**TOWN OF MOUNTAIN VILLAGE  
DESIGN REVIEW BOARD REGULAR MEETING  
THURSDAY DECEMBER 3, 2015, 10:00 AM  
2nd FLOOR CONFERENCE ROOM, MOUNTAIN VILLAGE TOWN HALL  
455 MOUNTAIN VILLAGE BLVD, MOUNTAIN VILLAGE, COLORADO  
AGENDA**

**TO:** Design Review Board  
**FROM:** Dave Bangert, Town Forester  
**FOR:** Meeting of December 3, 2015  
**DATE:** November 25, 2015  
**RE:** Consideration of a Design Review application for a new single-family dwelling on Lot 600BR-2

**Application Overview:** The purpose and intent of this memo is to have a Design Review Board (DRB) review and approve a new single family home on Lot 600BR-2.

CONSTRUCTION STAGING PLAN  
SCALE: 1/8" = 1'-0"

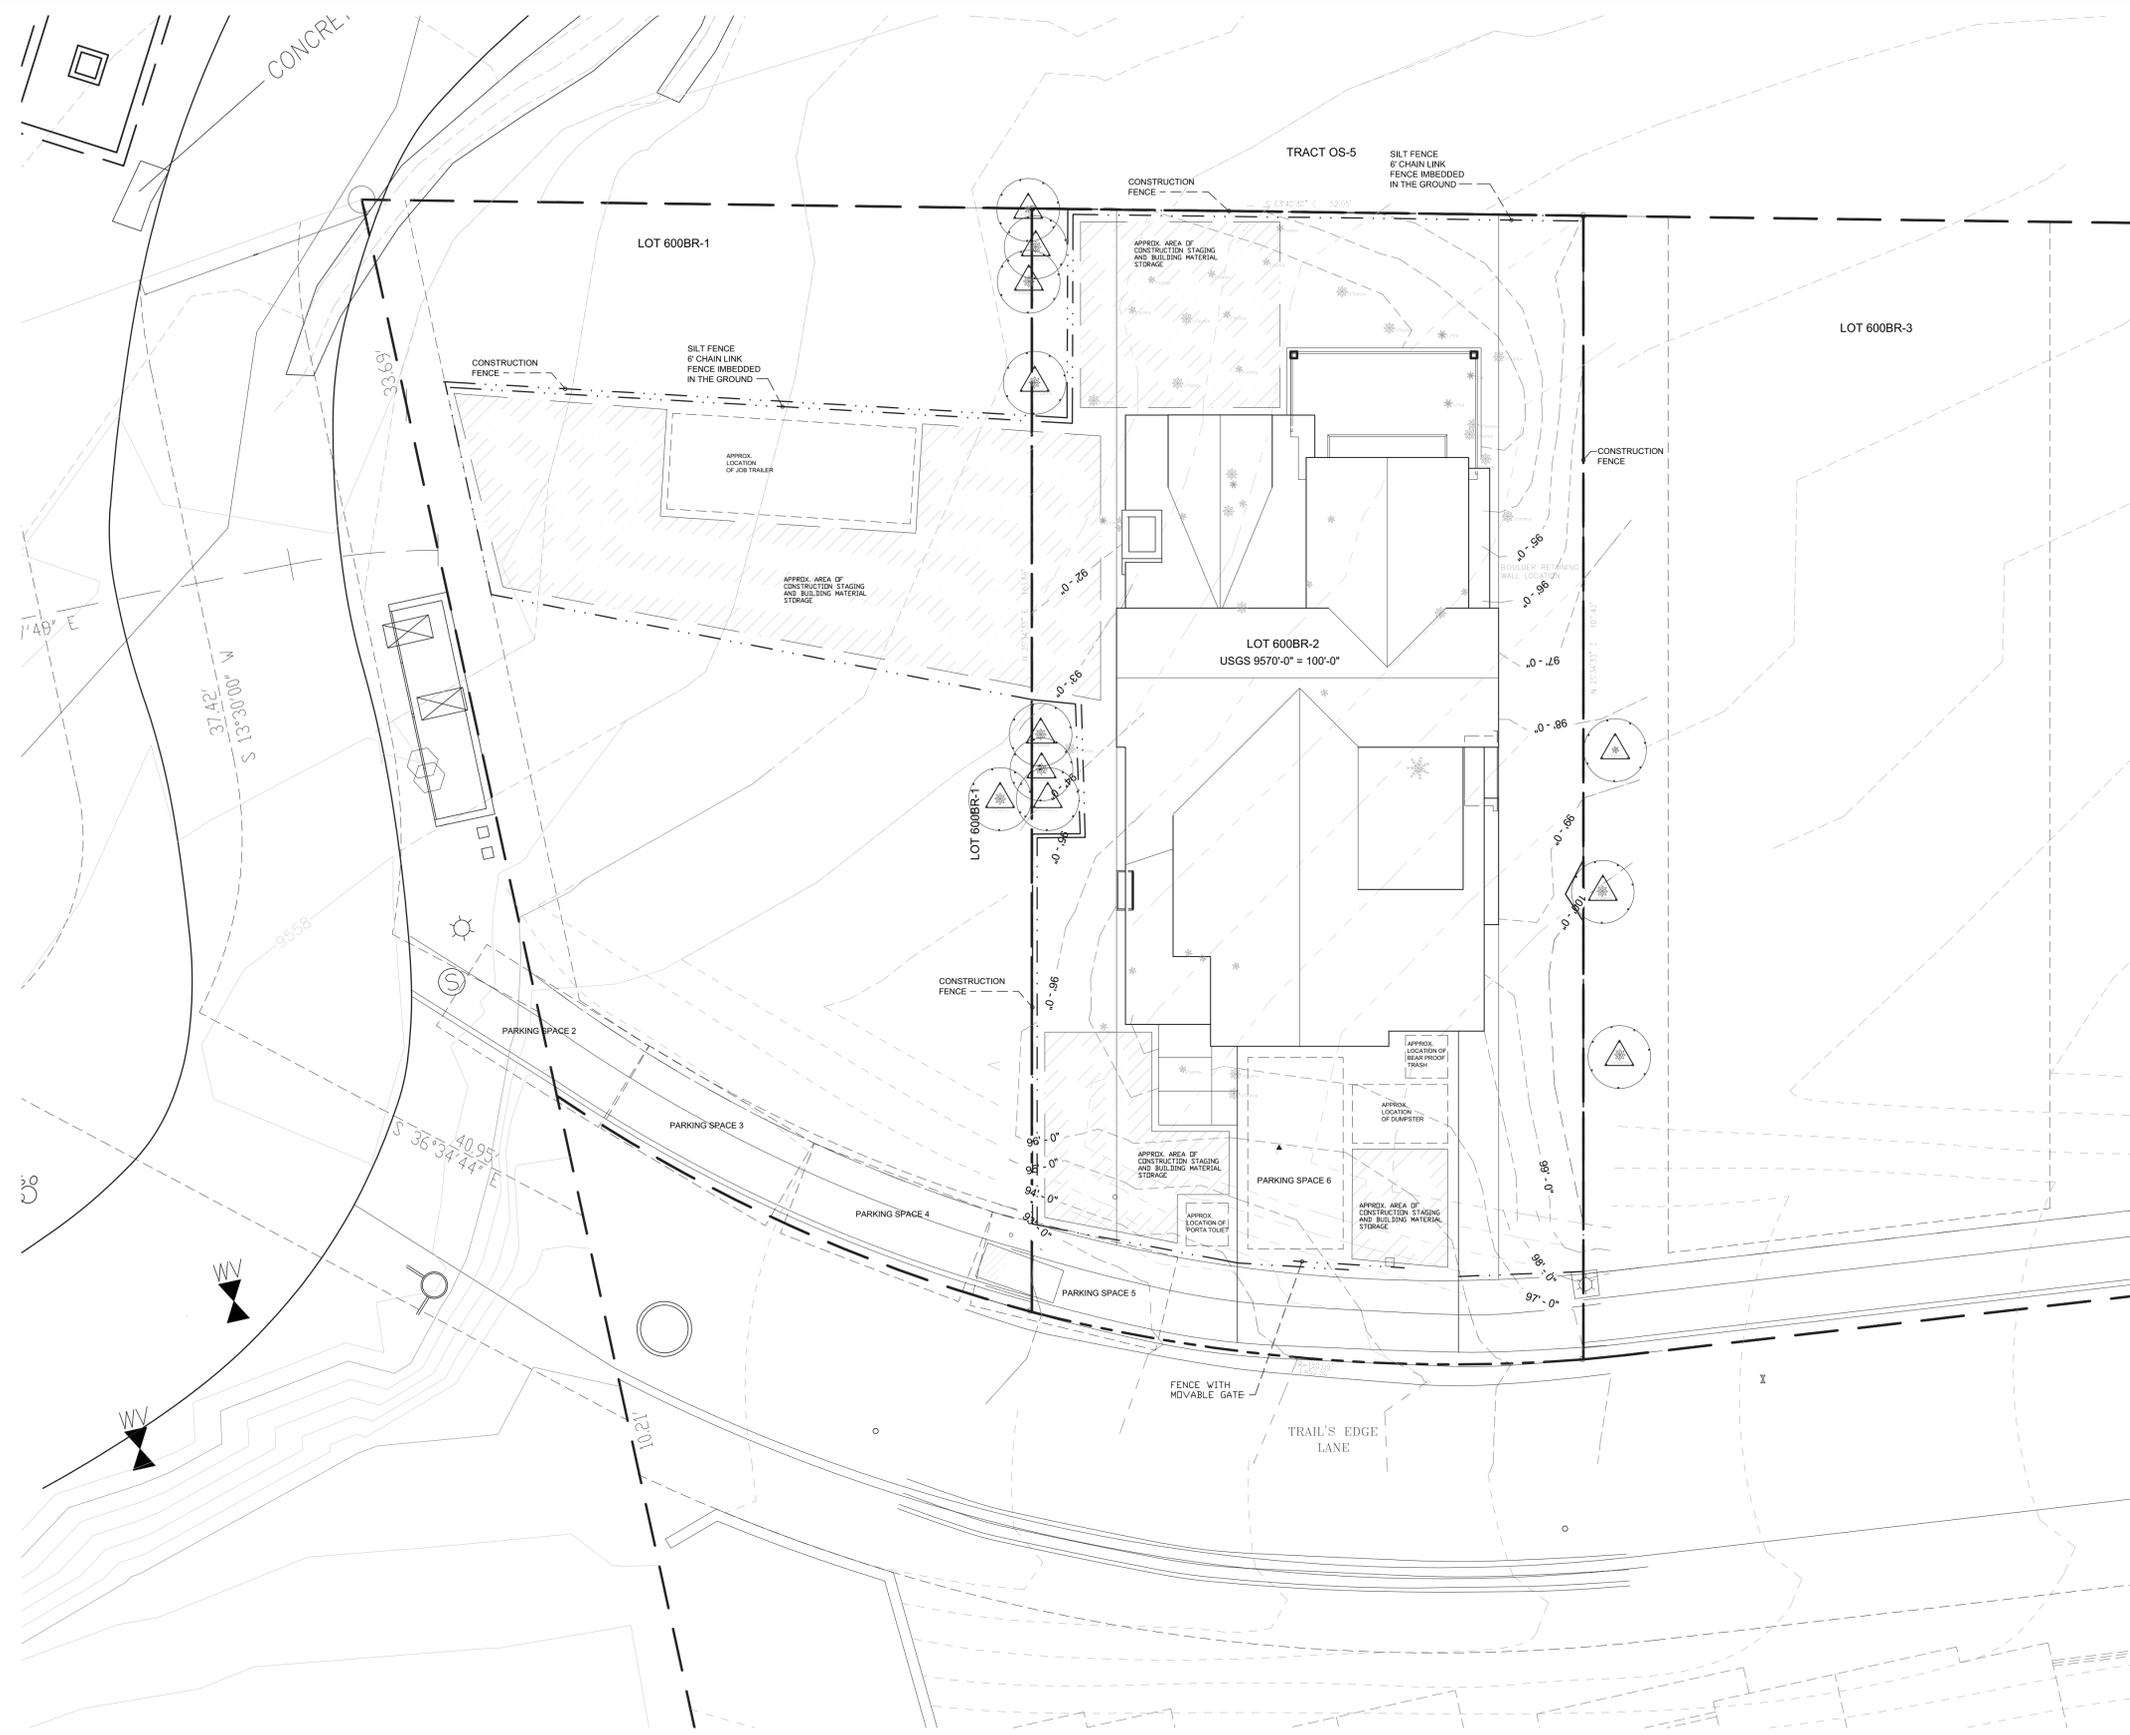
The layout and roof line of the unit is located completely within the allowable buildable area of the lot with no encroachments proposed. However, some disturbances, tree removal and construction staging is proposed within 8' Setbacks surrounding the buildable area. The DRB should review the site plan and determine whether the construction staging encroachments into the 8' Setbacks would cause unreasonable negative impacts to the surrounding properties. Because the foundation is less than 5' from the setbacks a monument survey of the footers will be required before the pouring of concrete. This will be a condition of approval.

The applicant is proposing to use Lot 600BR-1 for some of their construction staging as per the license agreement.

2 A204 ROOF PLAN  
1/4" = 1'-0"

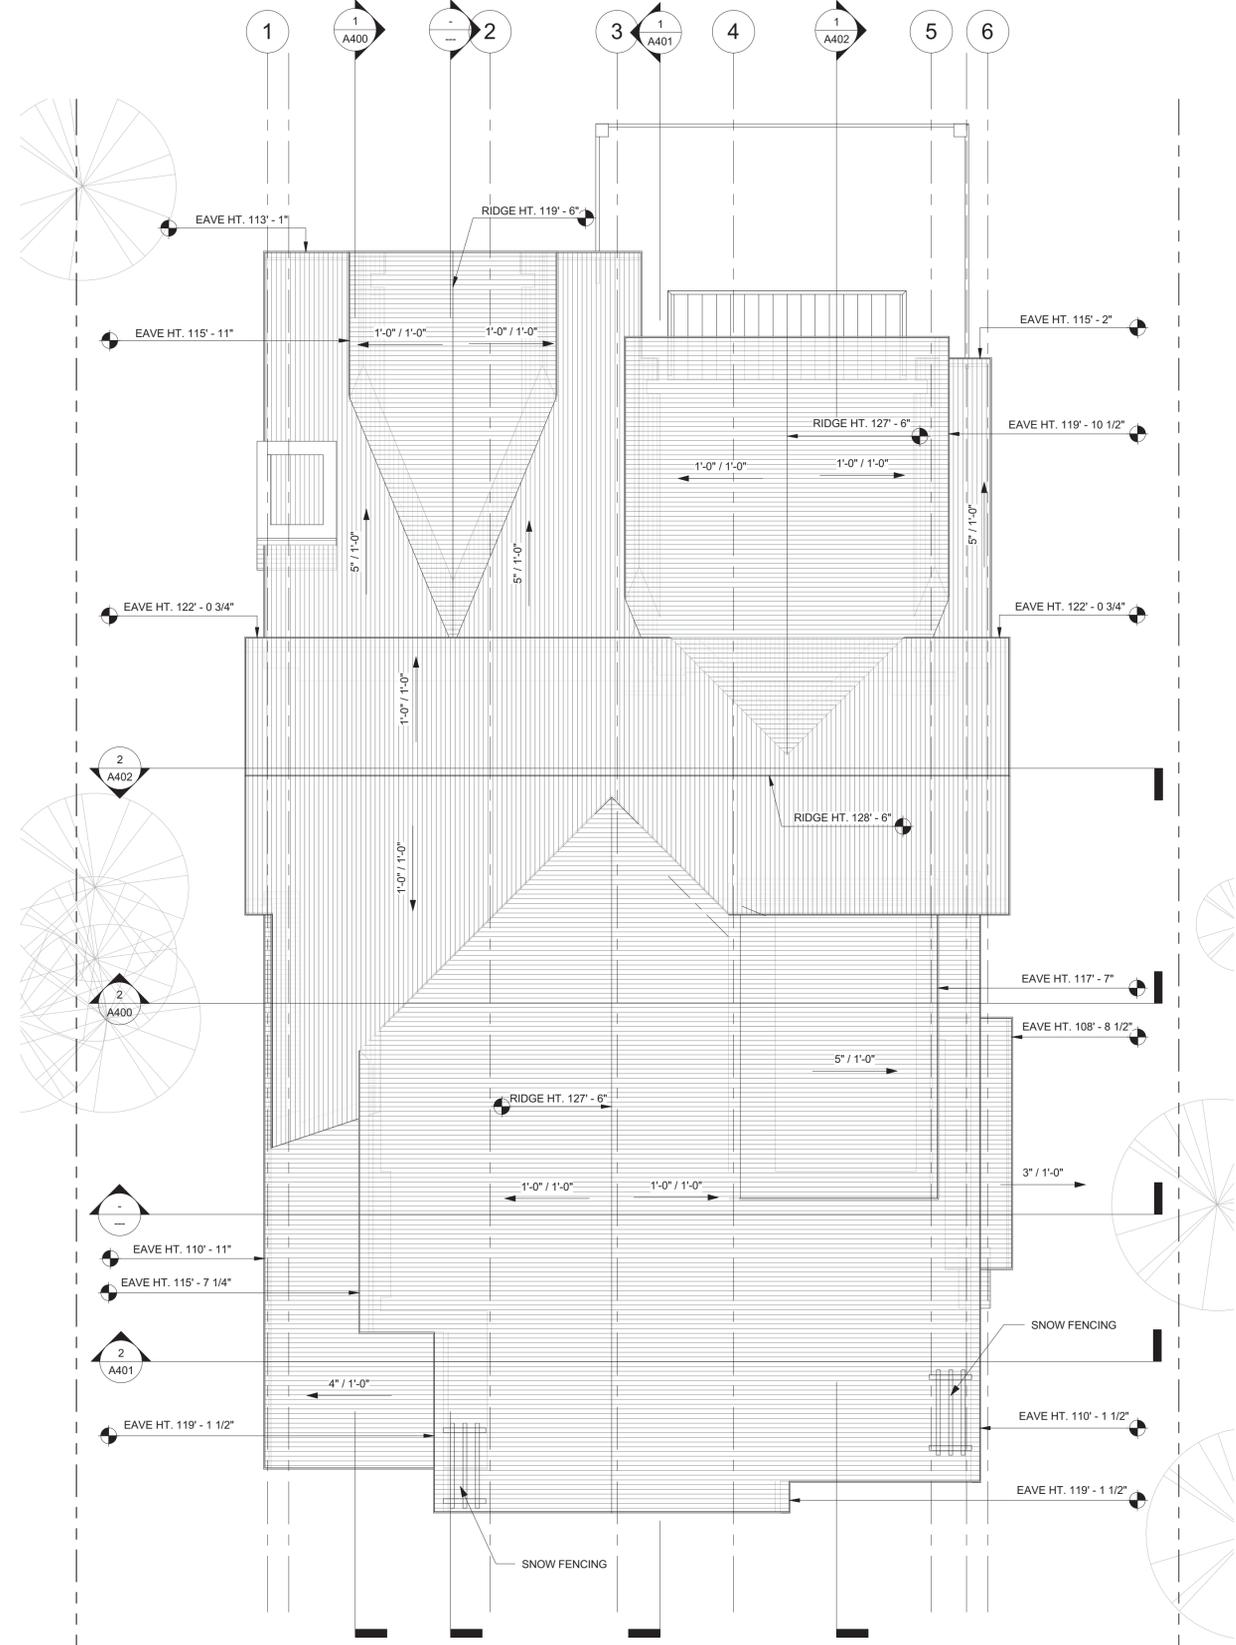
The CDC allows for primary roof pitches to be between 6:12 and 12:12 and be gable in form, and secondary roofs will not have pitches less than 4:12 and be either gable or shed in form. With this in mind, the roof plan illustrates that a shed roof form for the garage east pop out will have a 3:12 slope, requiring a variation. All other roof slopes are compliant.

1. Proposed secondary shed roof with 3:12 pitch as outlined in CDC Section 17.5.6.(C)(2)(b).

6. The proposed development meets all applicable Town regulations and standards because, without limitation a design variation have been granted for:
  - a. Roof pitch of 3:12 on a secondary roof form;

**Grading,  
Drainage,  
and  
Utility  
Plan**

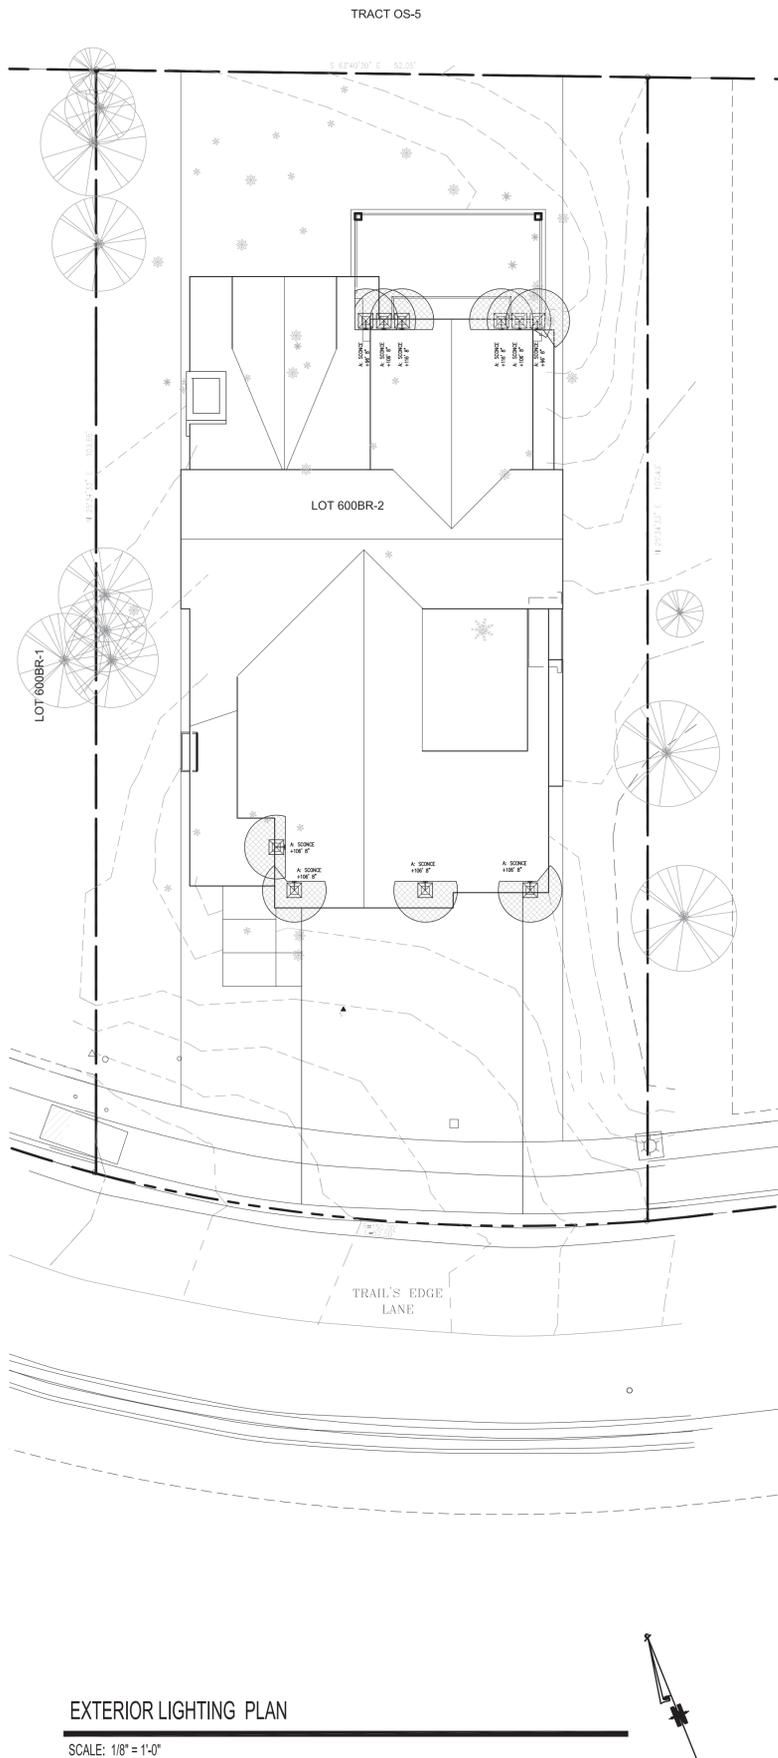
The applicant has provided a grading and drainage plan prepared by Uncompahgre Engineering for the proposed development. Positive drainage away from the structure has been created. The plan includes piping within the 8' Setbacks. An 18" culvert is being shown under the driveway at the road. Grading on the site blends with the natural topography.
